Liberty High Charter School

BD21-LF007-001
MUP - 15-027 (m1)

CHANGE

PROJECT IS REQUESTING A MINOR DEVIATION TO THE SIZE OF BUILDING B FROM THE EXISTING MUP. BUILDING B IS LARGER BY 2,730 SF. THIS INCREASED AREA IS WITHIN THE BOUNDARIES OF THE INTERNAL COURTYARD AREA. THE ENLARGED BUILDING FOOTPRINT REPLACES PREVIOUSLY DESIGNED IMPERVIOUS PAVEMENT AREA. THE ENLARGED BUILDING AREA IS REQUIRED TO PROVIDE APPROPRIATE PROGRAM SQUARE FOOTAGE FOR CURRENT TEACHING METHODOLOGY. THERE IS NO INCREASE IN TOTAL STUDENTS OR FACULTY BEING REQUESTED FROM THIS MINOR DEVIATION REQUEST. ALL ELEMENTS OF BUILDING B REMAIN RELEVANT TO THE INTENDED AESTHETIC APPROVED BY THE MUP. ROOF HEIGHTS, MATERIALS, SITE LOCATION, ETC. WINDOW AND DOOR LOCATIONS HAVE BEEN ADJUSTED TO ACCOUNT FOR THE LARGER BUILDING FOOTPRINT.

A-101

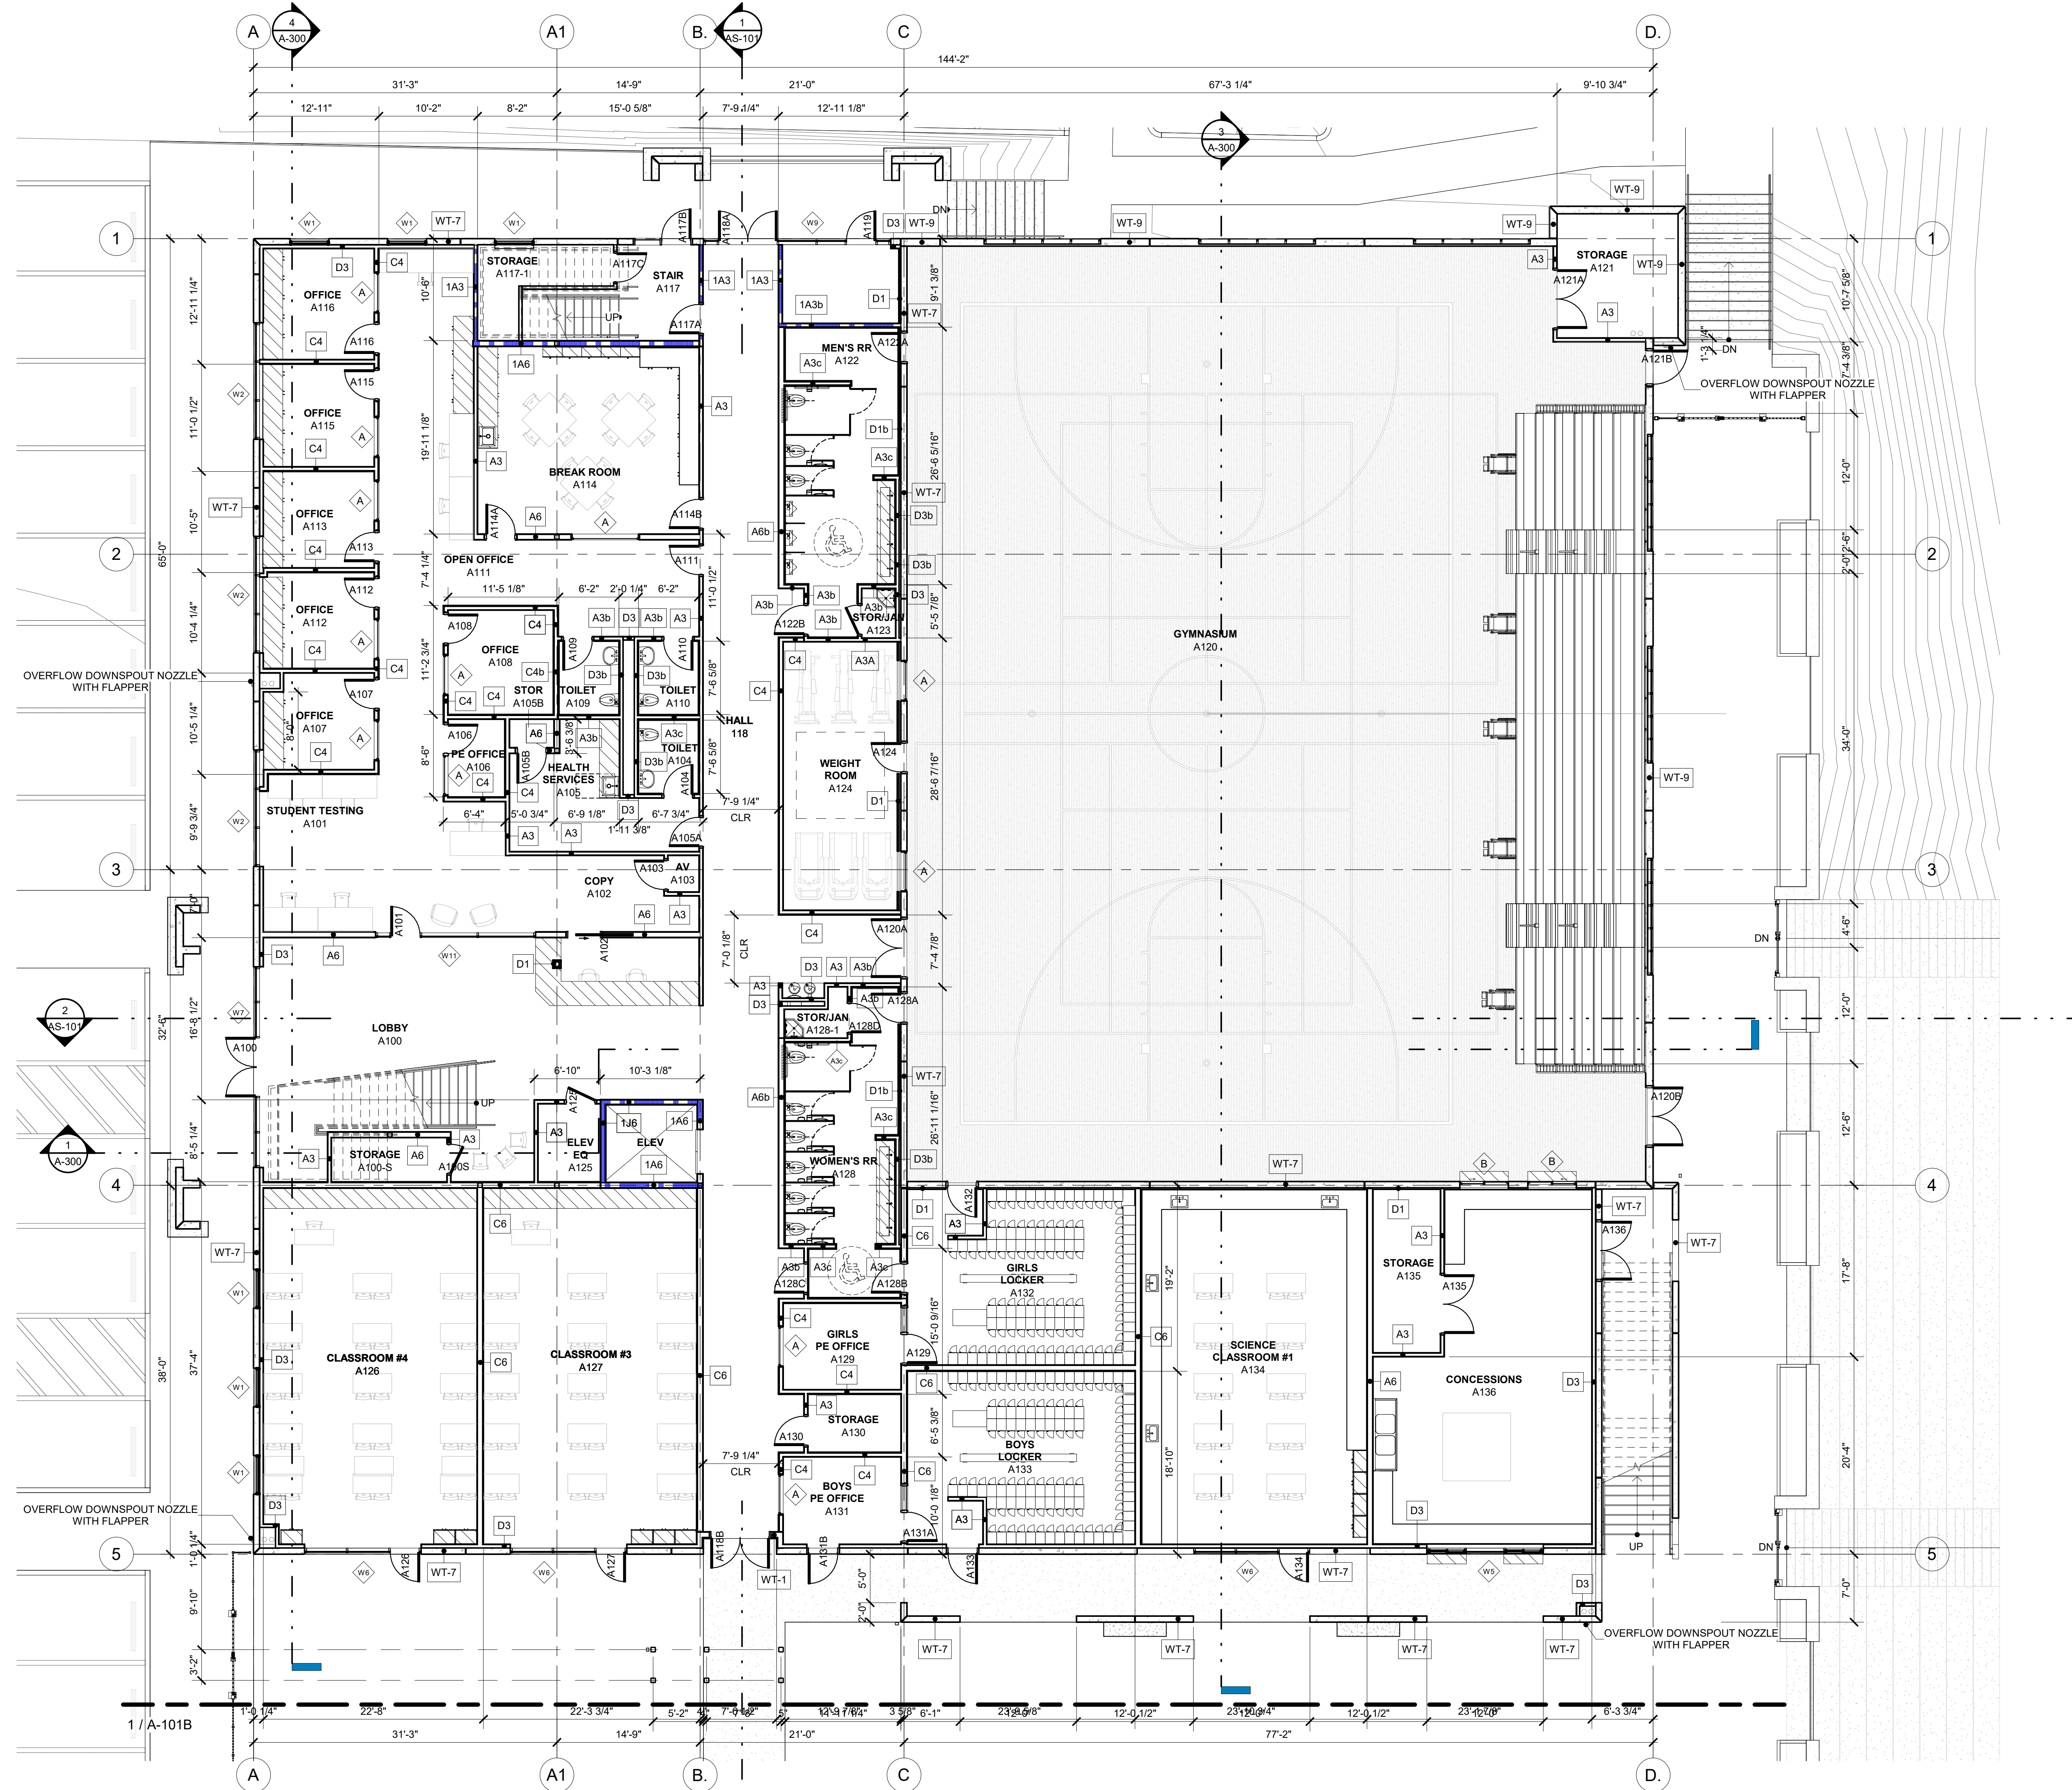
SECTOR B
 PROPOSED SQUARE FOOT = 8671 SFT
 CHANGE = 1365 SFT

*NOTE
 DIMENSION CHANGED FROM 38'-0" TO 44'-0"
 DIMENSION CHANGED FROM 35'-0" TO 50'-0"

A-101B

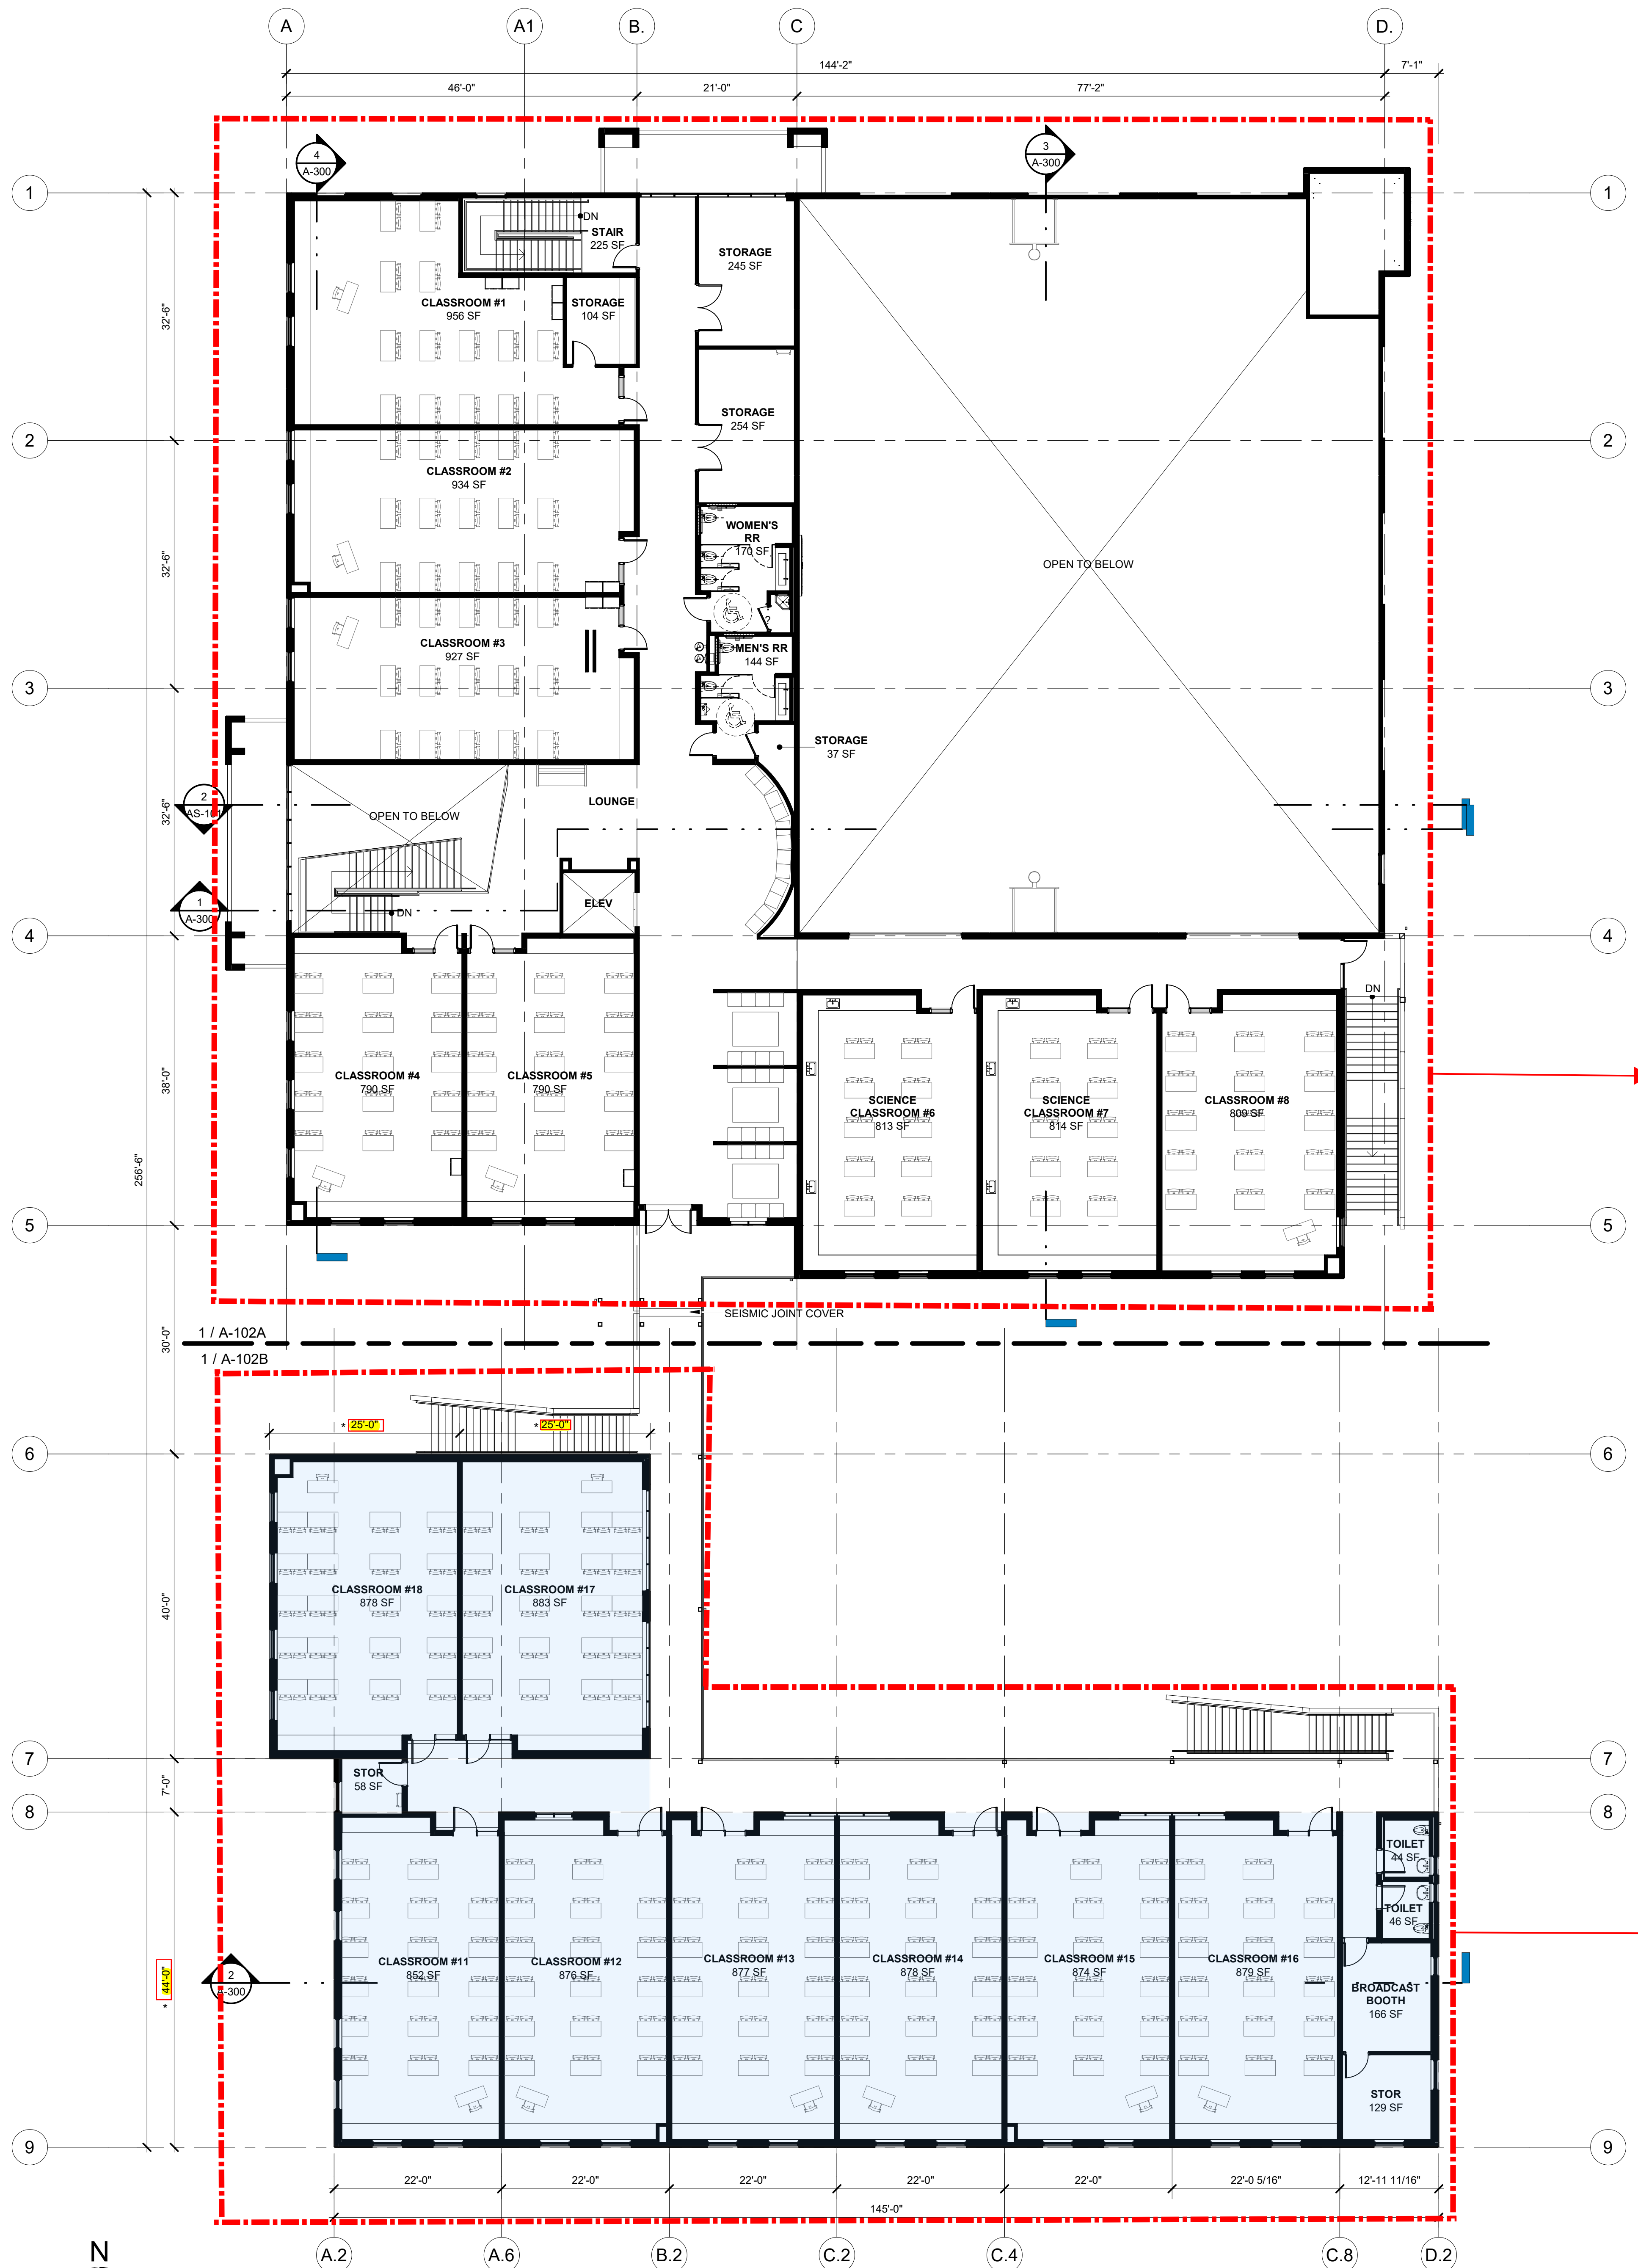
SECTOR B
PROPOSED SQUARE FOOT = 8671 SFT
CHANGE = 1365 SFT

*NOTE
DIMENSION CHANGED FROM 38'-0" TO 44'-0"
DIMENSION CHANGED FROM 35'-0" TO 50'-0"
